NORTHERN BEACHES COUNCIL LOCAL TRAFFIC COMMITTEE MEETING

TUESDAY 5 APRIL 2022

- 4.21 Manly High Pedestrian Activity Area Infrastructure Package 2 .**Error! Bookmark not defined.**
- 4.22 Oliver Street and Bennett Street - Hybrid dedicated cycleway and shared user path connecting Freshwater Village and Curl Curl Sports Precinct**Error! Bookmark not defined.**

**MANLY HIGH PEDESTRIAN ACTIVITY AREA
INFRASTRUCTURE PACKAGE 2**

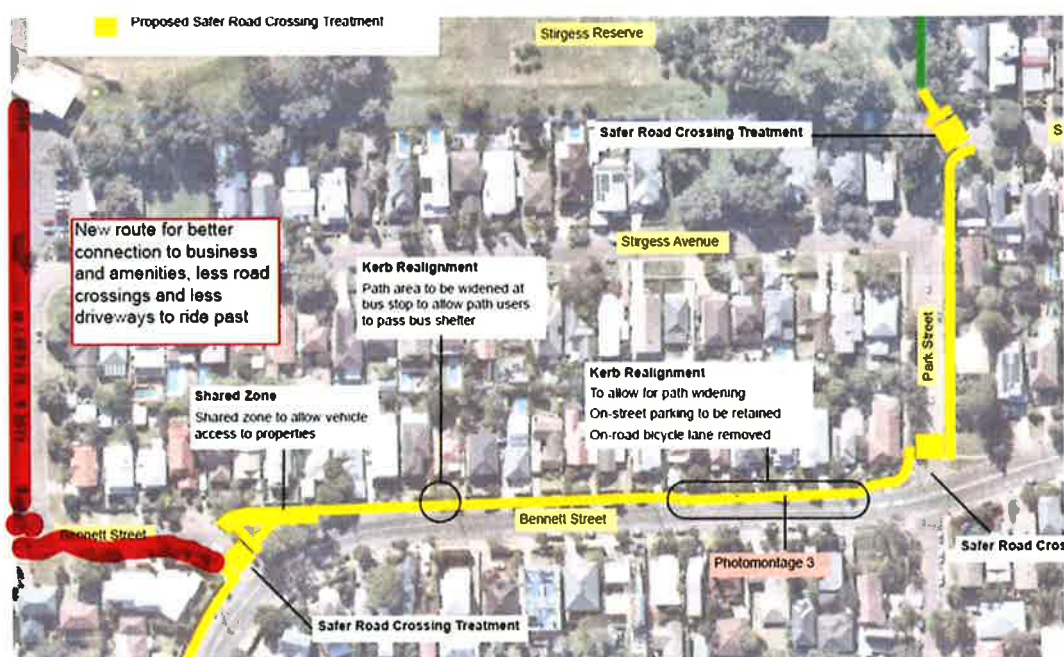
Whilst the goal of connecting local businesses, schools and amenities via a shared bike path is good, the current design of the plan could be improved. The purpose is to connect Freshwater Village with Schools and surrounding businesses so this should be paramount whilst limiting the amount of road crossings, number of driveways being passed and shared areas with cars for safety reasons.

- A better end point to the bike path would be to connect into the Bowling Club, JC's Pizza, Harbord Kikoff, The AFL / Cricket Club and surrounding sporting fields and facilities

- Avoids the needs of 2 road crossings (crossing Park St and then crossing Stewart st)
 - Avoids the need to widen the footpath along Bennet st and to remove the existing cycleway that continues along Bennet, Adams and onto Carrington Pde

Making these modifications to improve the outcome of this plan would be simpler, connect more businesses and avoid potential safety issues with road crossings, shared car / bike area and crossing over 23 driveways.

A marked up version of the concept plan is attached.

Figure 5:
Configuration proposed for Option 1A, adjusted
to meet TNSW's recommended lane widths
(Source: Northern Beaches Council)

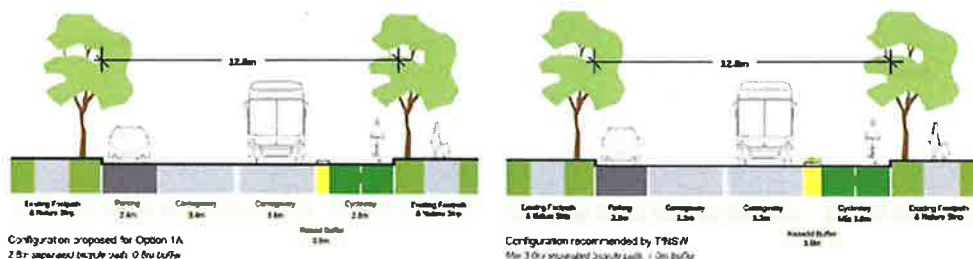
Option 1A will create a high-quality contribution to the Northern Beaches Safe Cycling Network. The wide bicycle path will encourage more bike riding and active travel, helping to meet Council's mode shift targets. However, we suggest adjusting the widths of the vehicle and parking lanes to create a best-practice 3.0m wide bike path with a 1.0m buffer. Figure 4 shows the configuration recommended by Transport for NSW for a 12.8m road. In Figure 5, these widths are applied to Oliver Street and presented alongside Council's proposal for Option 1A.

Figure 7: Configuration proposed for Option 1B, adjusted to meet TNSW's recommended lane widths. (Source: Northern Beaches Council)

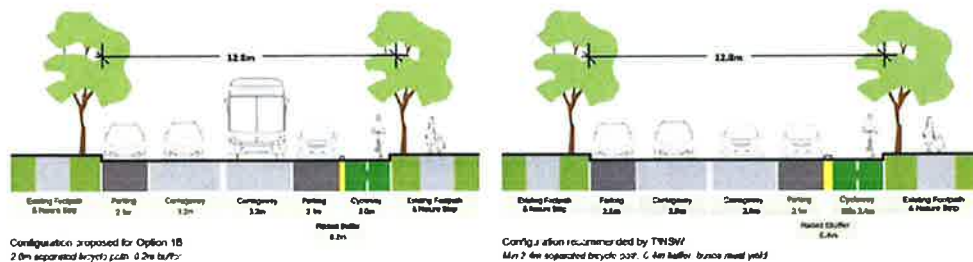
- Option 1B could be considered for some sections, but with a 2.4m wide bicycle path.

Where buses do not pass regularly, it may be possible to retain parking on both sides of the road and create an adequate bicycle path by narrowing the vehicle and parking lanes. The Cycleway Design Toolbox suggests the configuration shown in Figure 6 to achieve an acceptable 2.4m bicycle path with a 40cm buffer. Figure 7 demonstrates how Option 1B could be adjusted to create the recommended layout.

OPTION 1 C

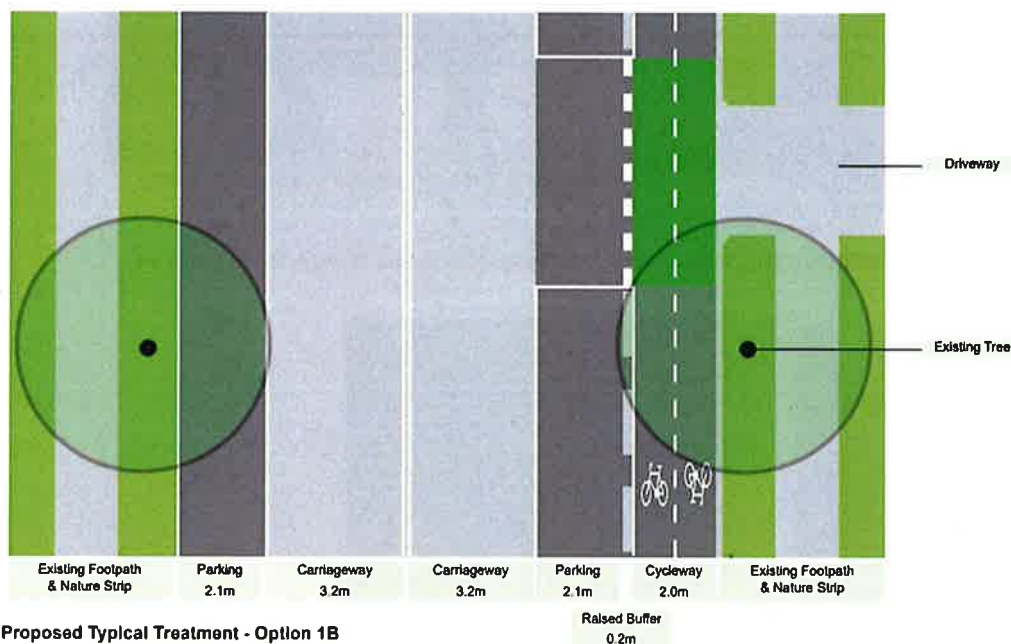
With BOTH option 1A and 1B the cycle lane width does not allow for a 2 cyclists in each direction in PEAK use days.

So an OPTION that provides a wider Cycleway perhaps by removing the EXISTING TREE and Widening the Cycleway (using part of the Nature Strip ?) and FIXING the kerb (as has been done in City of Sydney in George Street for widening the walking space adjacent to the Light Rail Route).

This preserves the 2-way CAR LANE LAYOUT.(but losing a row of Street Trees which can be re-planted on the other side of Street or perhaps within the NATURE STRIP if width allows ?).
